UNITED STATES
DEPARTMENT OF THE INTERIOR
BUREAU OF LAND MANAGEMENT**SUNDRY NOTICES AND REPORTS ON WELLS**
Do not use this form for proposals to drill or to re-enter an abandoned well. Use form 3160-3 (APD) for such proposals.

7. If Unit or CA/Agreement, Name and/or No.
891000303X8. Well Name and No.
POKER LAKE UNIT 28 BS 106H9. API Well No.
30-015-45507-00-X110. Field and Pool or Exploratory Area
PURPLE SAGE-WOLFCAMP (GAS)11. County or Parish, State
EDDY COUNTY, NM**SUBMIT IN TRIPLICATE - Other instructions on page 2**

XTO Permian Operating, LLC requests permission to make the following changes to the original APD:

DRILLING PLAN: BLM COMPLIANCE
(Supplement to BLM 3160-3)

13-3/8" x 9-5/8" x 5-1/2" 10M RSH-2 Wellhead
Assembly, With T-EBS-F Tubing Head

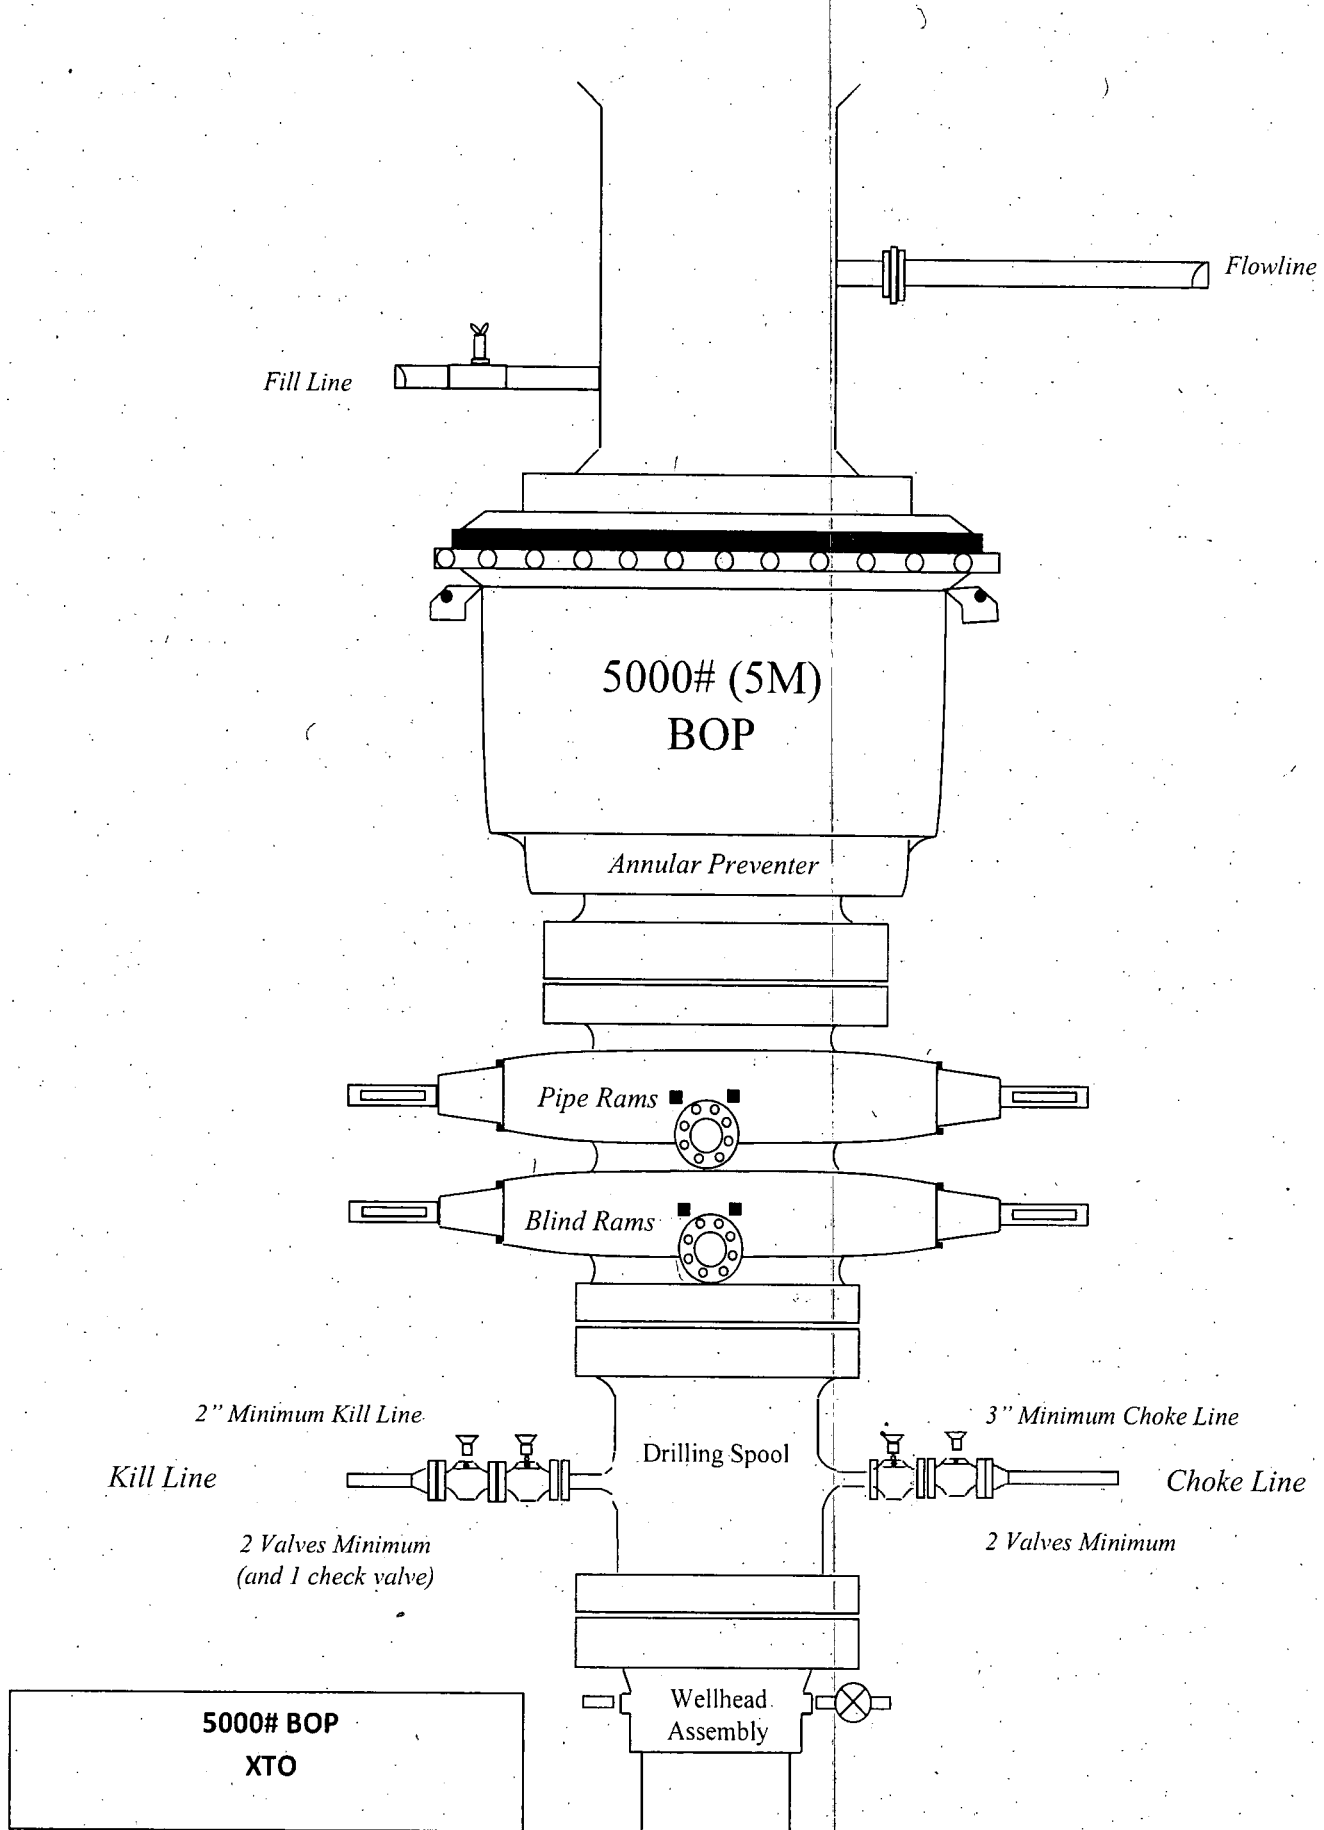
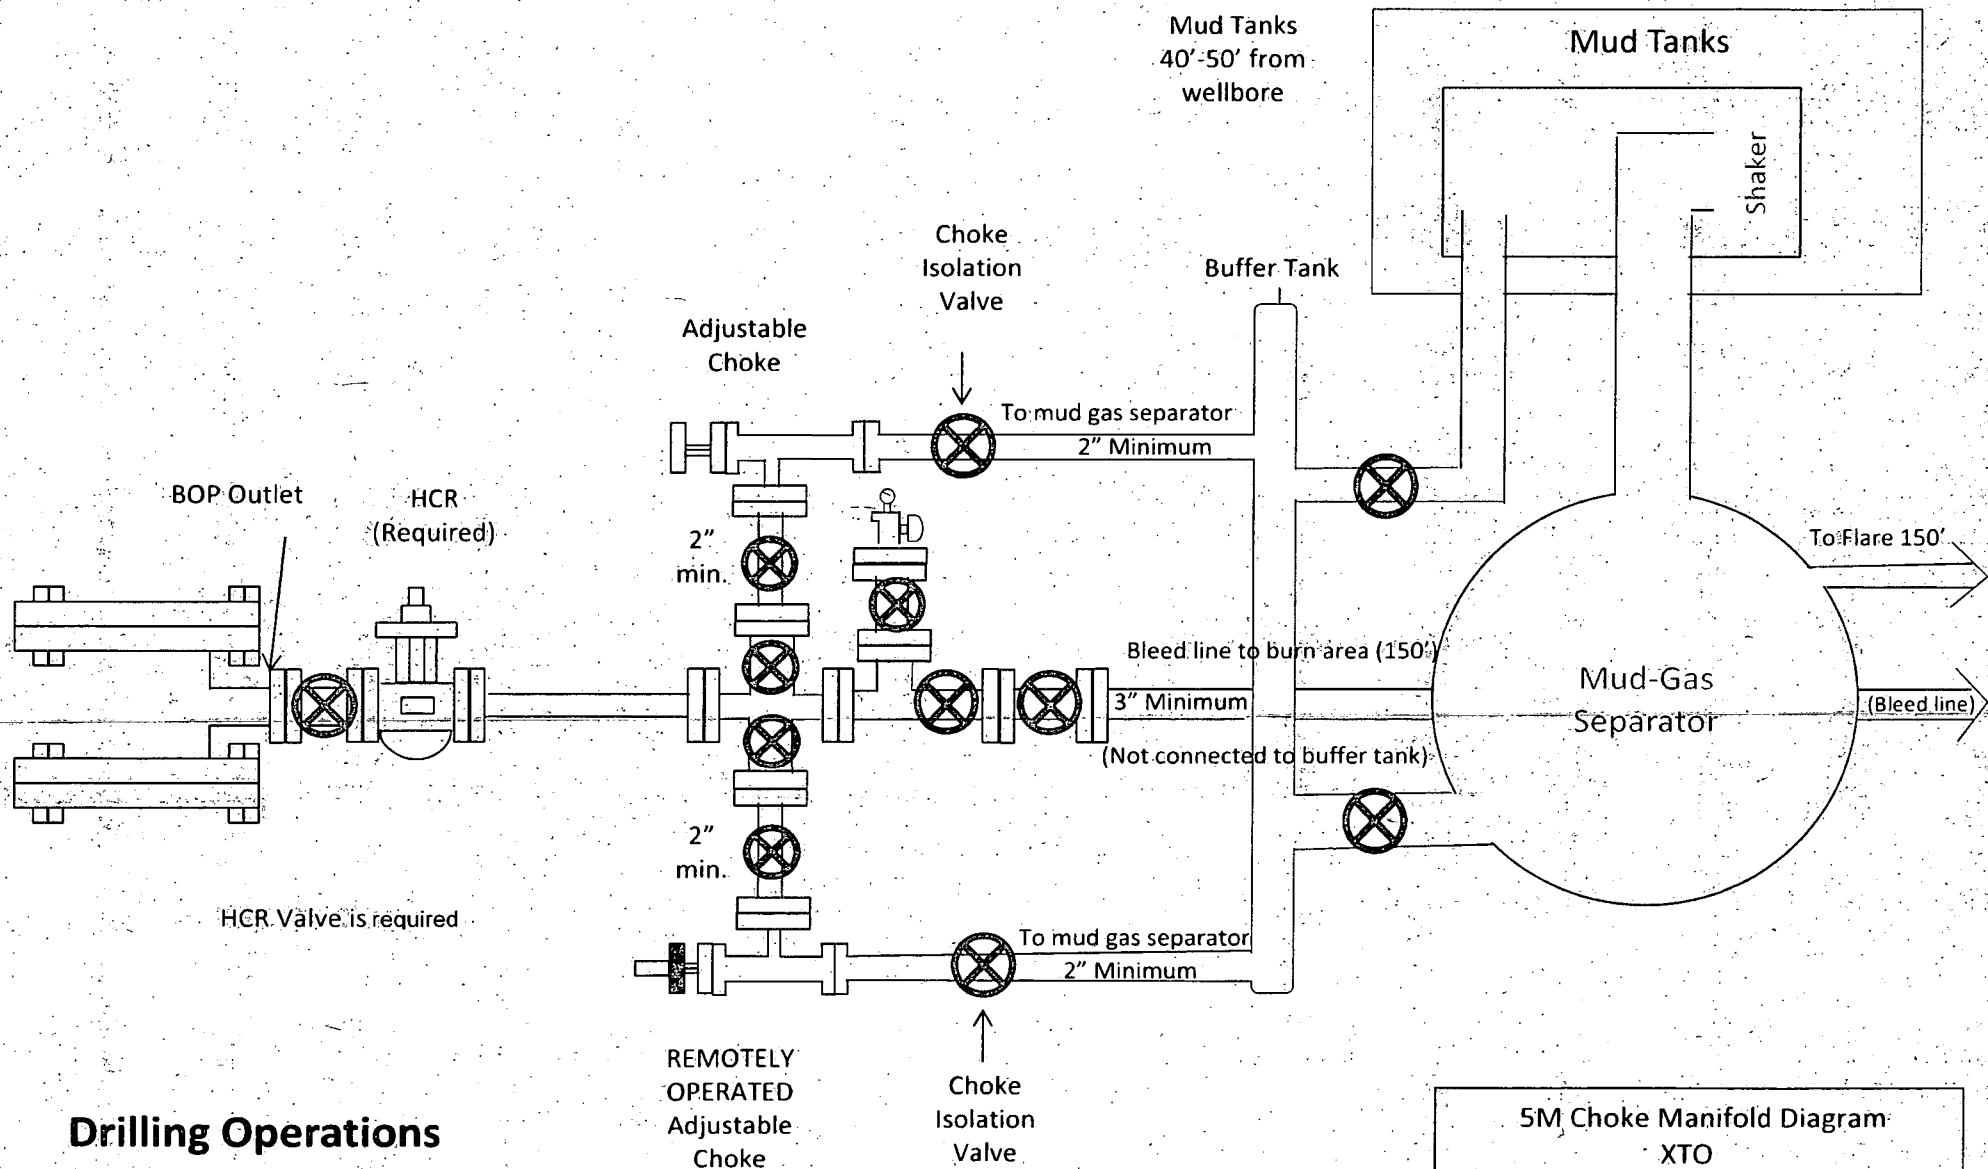
WELLHEAD:

Permanent Wellhead - GE-RSH Multibowl System

A. Starting Head (RSH System): 13-3/8" SOW bottom x 13-5/8" 5M top flange

B. Tubing Head: 13-5/8" 5M bottom flange x 7-1/16" 10M top flange

- Wellhead will be installed by manufacturer's representatives.
- Manufacturer will monitor welding process to ensure appropriate temperature of seal.
- Operator will test the 9-5/8" casing per Onshore Order 2.
- Wellhead manufacturer representative may not be present for BOP test plug installation

3. **Operator has proposed a multi-bowl wellhead assembly. This assembly will only be tested when installed on the surface casing. Minimum working pressure of the blowout preventer (BOP) and related equipment (BOPE) required for drilling below the surface casing shoe shall be 5000 (5M) psi.**

- a. **Wellhead shall be installed by manufacturer's representatives, submit documentation with subsequent sundry.**
 - b. **If the welding is performed by a third party, the manufacturer's representative shall monitor the temperature to verify that it does not exceed the maximum temperature of the seal.**

- c. **Manufacturer representative shall install the test plug for the initial BOP test.**
 - d. **Operator shall perform the intermediate casing integrity test to 70% of the casing burst. This will test the multi-bowl seals.**

- e. **If the cement does not circulate and one inch operations would have been possible with a standard wellhead, the well head shall be cut off, cementing operations performed and another wellhead installed.**

GRADE D PRESSURE TEST CERTIFICATE

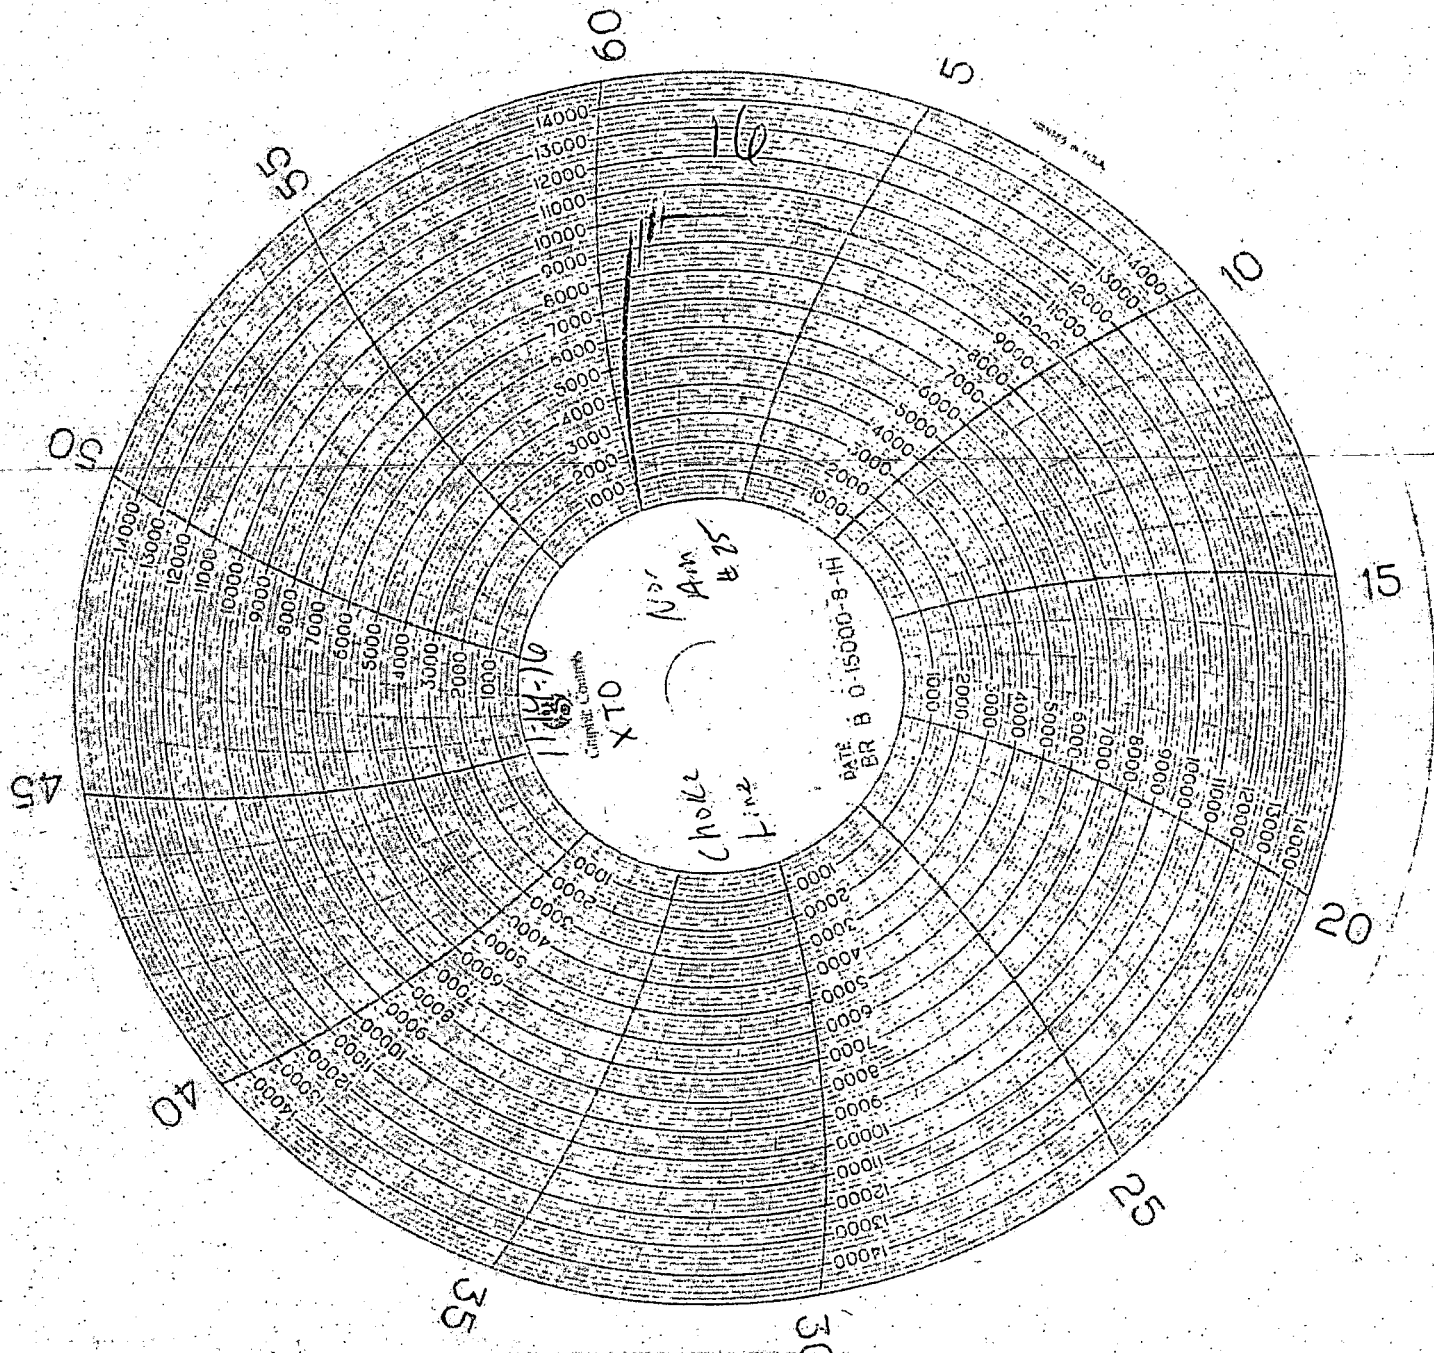
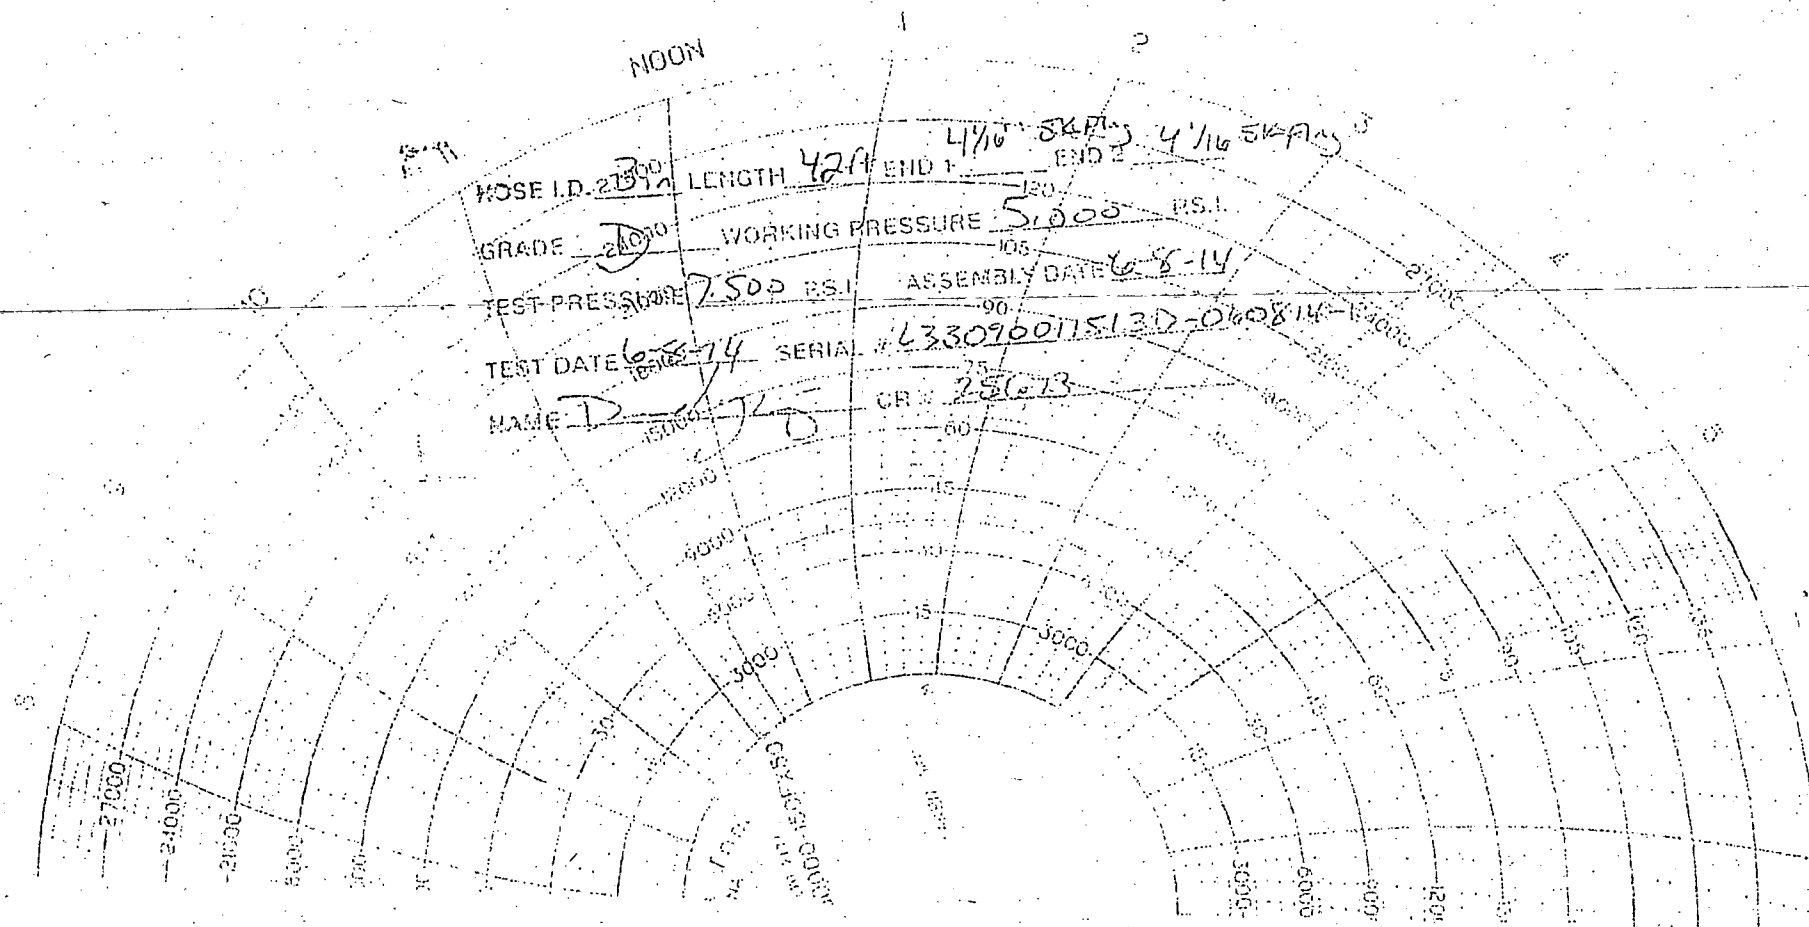
A variance is requested to allow use of a flex hose as the choke line from the BOP to the Choke Manifold. If this hose is used, a copy of the manufacturer's certification and pressure test chart will be kept on the rig. Attached is an example of a certification and pressure test chart. The manufacturer does not require anchors.

2. Variance approved to use flex line from BOP to choke manifold. Check condition of flexible line from BOP to choke manifold, replace if exterior is damaged or if line fails test. Line to be as straight as possible with no hard bends and is to be anchored according to Manufacturer's requirements. The flexible hose can be exchanged with a hose of equal size and equal or greater pressure rating. **Anchor requirements, specification sheet and hydrostatic pressure test certification matching the hose in service, to be onsite for review. These documents shall be posted in the company man's trailer and on the rig floor.** If the BLM inspector questions the straightness of the hose, a BLM engineer will be contacted and will review in the field or via picture supplied by inspector to determine if changes are required (operator shall expect delays if this occurs).
